## REMARKS

## **VERSION WITH MARKINGS TO SHOW CHANGES MADE**

FIG. 1

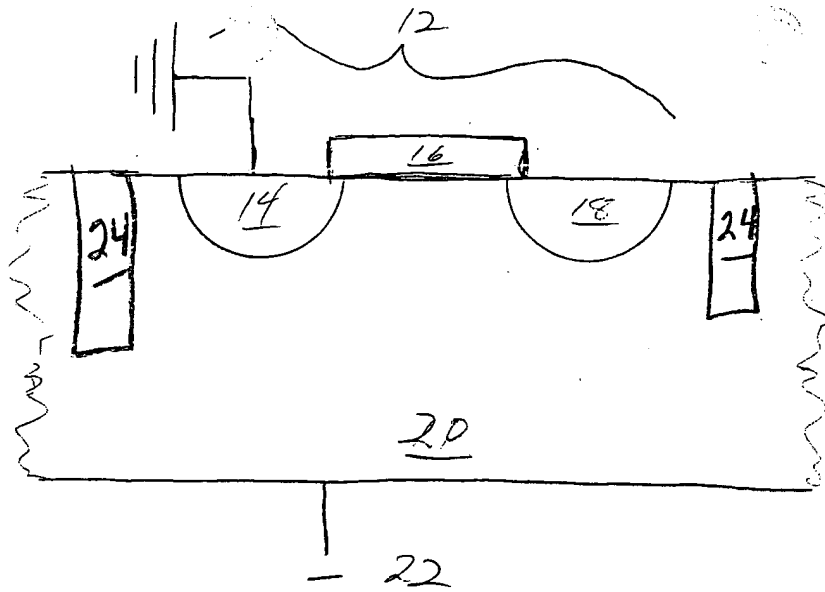
The drawings were objected to under 37 C.F.R. § 1.83(a). Although the "field oxide region" was described in the specification at page 7, line 21 to page 8, line 2, it was not shown in Fig. 1. Attached hereto is new Fig. 1 showing the field oxide region 24 surrounding the FET to correct the informality. Page 5, second complete paragraph has been amended to add the reference number "24." Support can be found at page 7, line 21 to page 8, line 2, i.e., LOCOS. No new matter is being added.

New Fig. 1 has been attached hereto.

The negative bias source 22 is adapted for applying a steady negative back bias to the substrate at a voltage that mitigates total dose radiation failures. The device operates by mitigating leakage currents about the device, while allowing the device to operate within its operational range, i.e., without changing the threshold voltage of the device to a degree that will cause the device to operate poorly. Typically, this negative bias will be between about -3V and about -0.5 V, relative to the source. The inventors have recognized that in the current generation of commercial CMOS devices, total dose radiation failures arise in the isolation region 24, rather than in the gate region.
